Final
ENVIRONMENTAL IMPACT STATEMENT

Quendall Terminals

Renton, Washington

August 2015

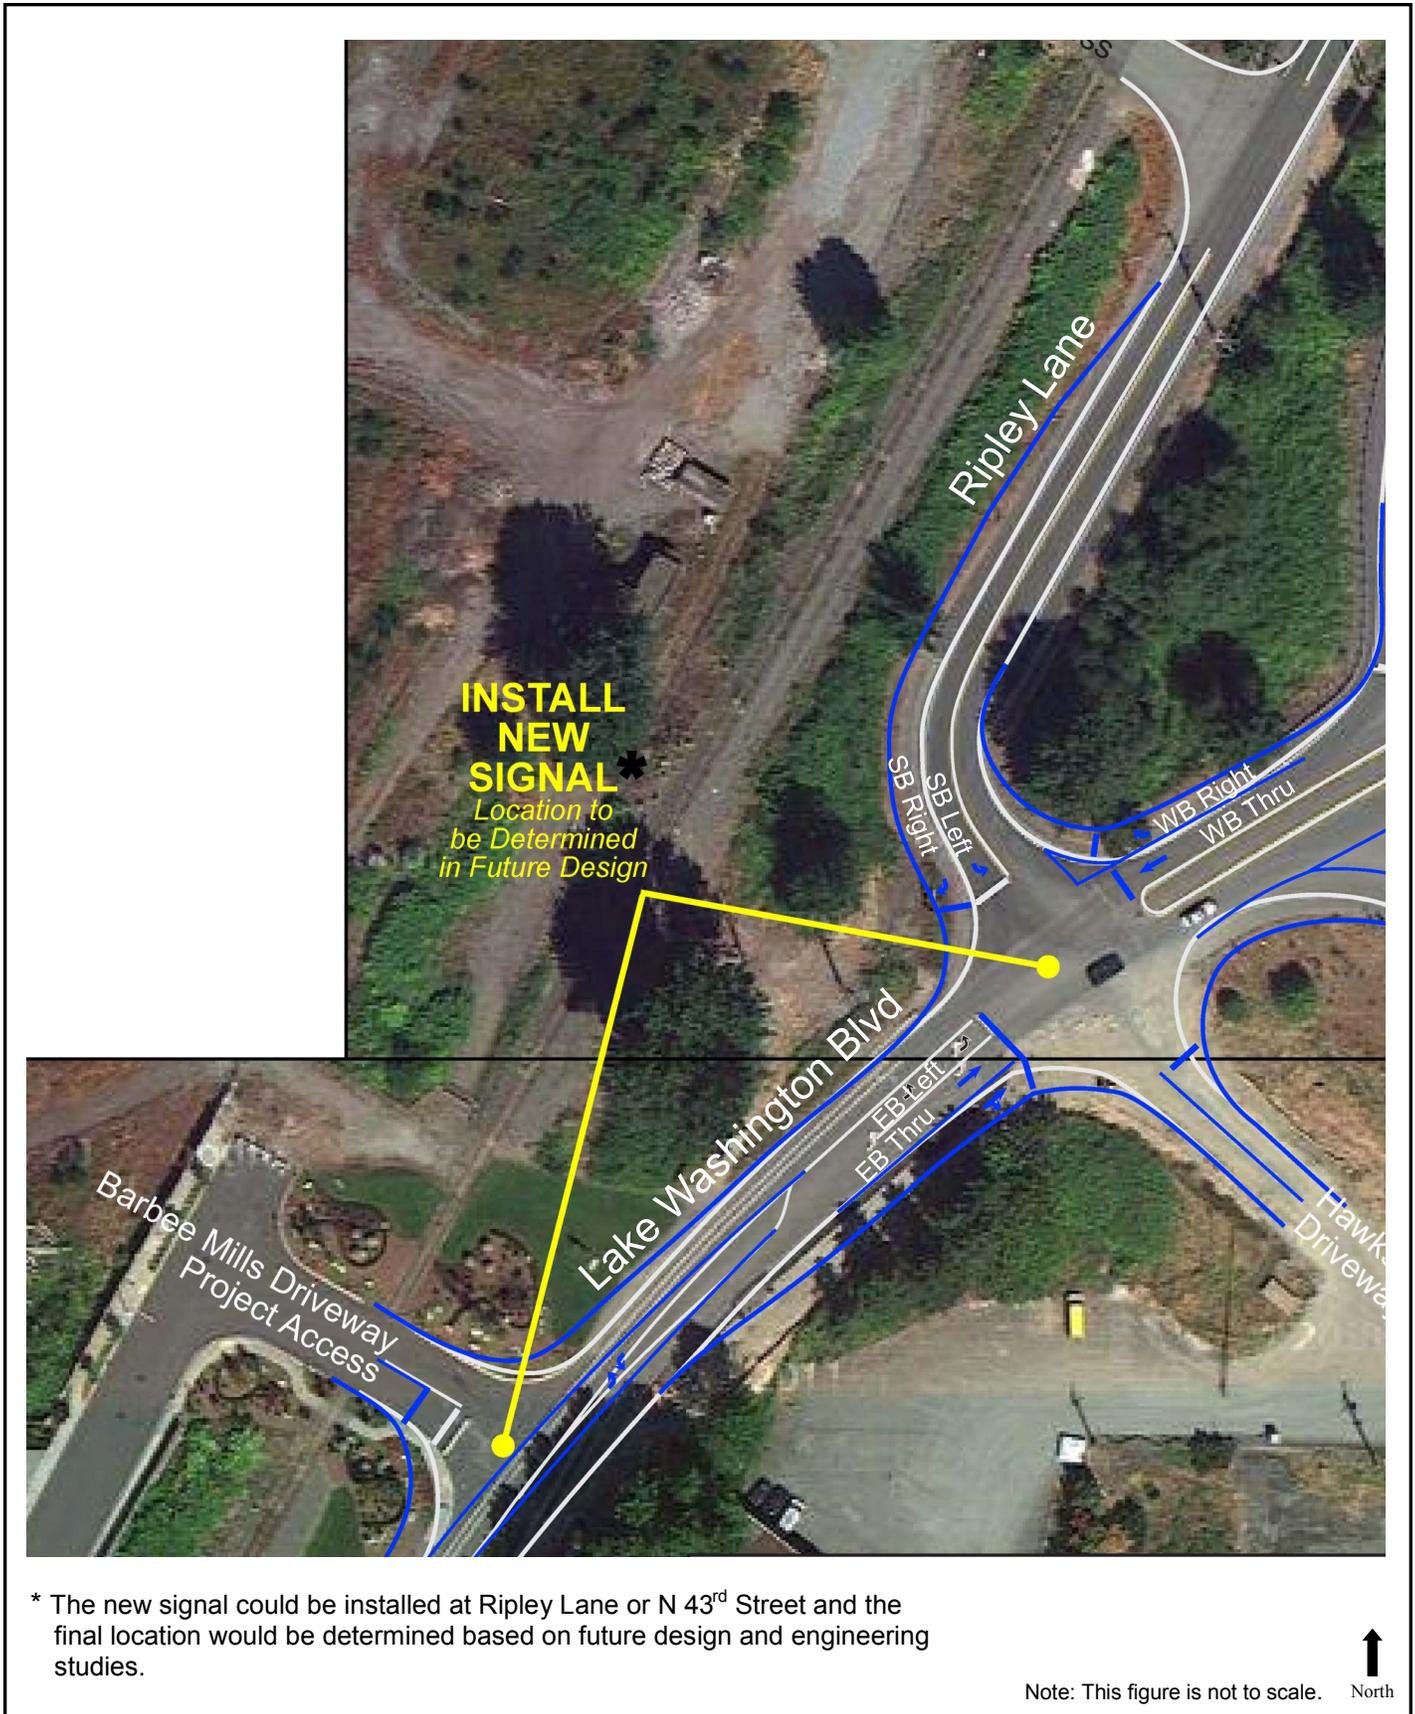
6. Your comment is noted for the record. The EIS Addendum (Section 3.4 and Appendix E) provided an updated analysis of vehicle queuing at key site intersections along Lake Washington Boulevard under various scenarios. With the project mitigation, vehicle queuing at the main site access (Ripley Lane and Lake Washington Boulevard) is estimated to be a maximum of approximately 200 feet for southbound left turn queues and 250 feet or less for eastbound queues during peak periods, and no blockage of adjacent intersections would occur (see FEIS **Figure 2-1** for a depiction of the traffic movements at this intersection).

Figure 2-2
 I-405/NE 44th Street Interchange and Lake Washington Boulevard Conceptual Improvements (without I-405 Improvements)

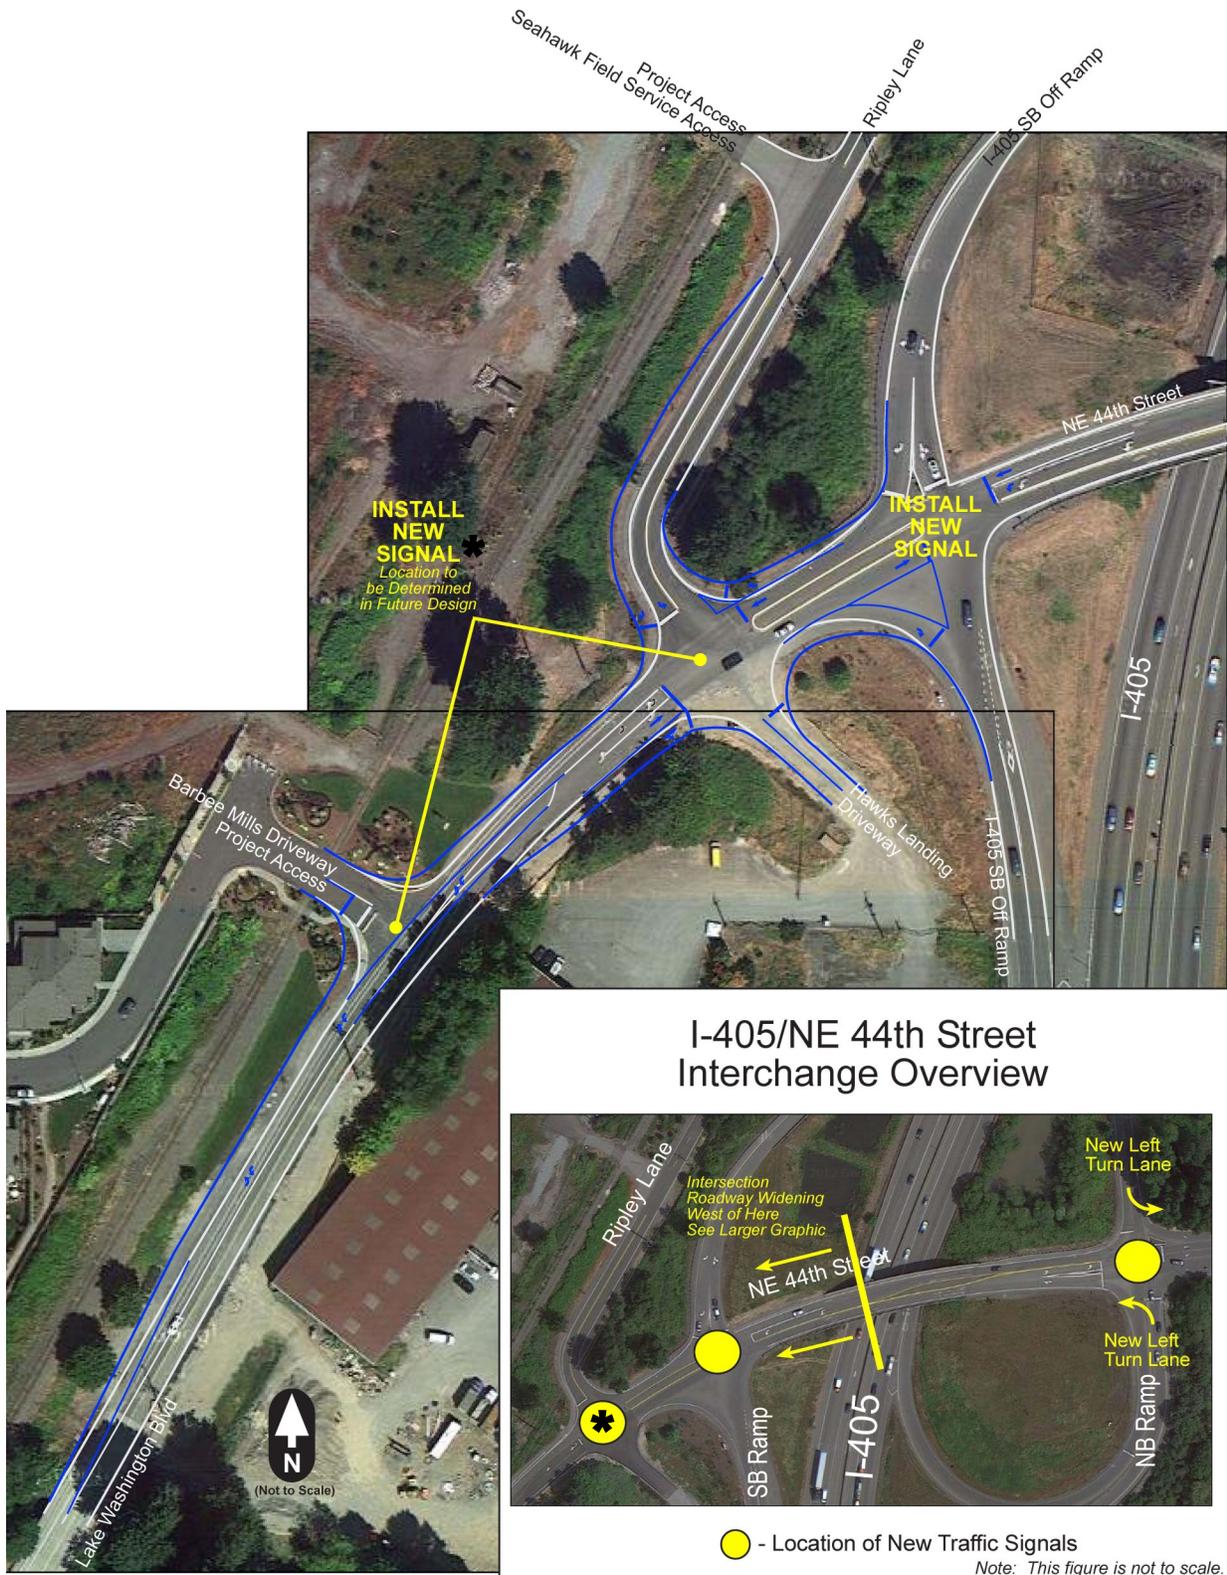
20. This FEIS identifies project-related mitigation measures for the site access intersection onto Lake Washington Boulevard at N 43rd Street and Ripley Lane. See FEIS **Figure 2-2** for a sketch of the conceptual improvements at the I-405/NE 44th Street interchange

4. Your comment is noted for the record.
5. Please see FEIS **Figure 2-2** for a conceptual sketch of the I-405/NE 44th Street interchange and Lake Washington Boulevard improvements (without I-405 Improvements). These improvements would be required to be implemented by the applicant to mitigate project-related traffic impacts.

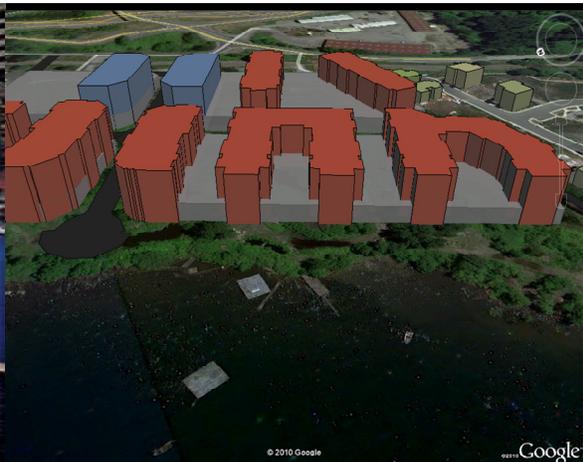
These renderings of the Quendall proposals are made using Google Earth polygon tools, with dimensions taken from the applicant's own submittals in the DEIS. The comparison images are made against publicly available aerial photographs of other local developments, and rotated to allow viewing from similar perspective as the aerial photographs. Readers will note the staggering difference in the size, density and sprawl of the Quendall proposal versus other lakefront developments that are, by most standards, already large.
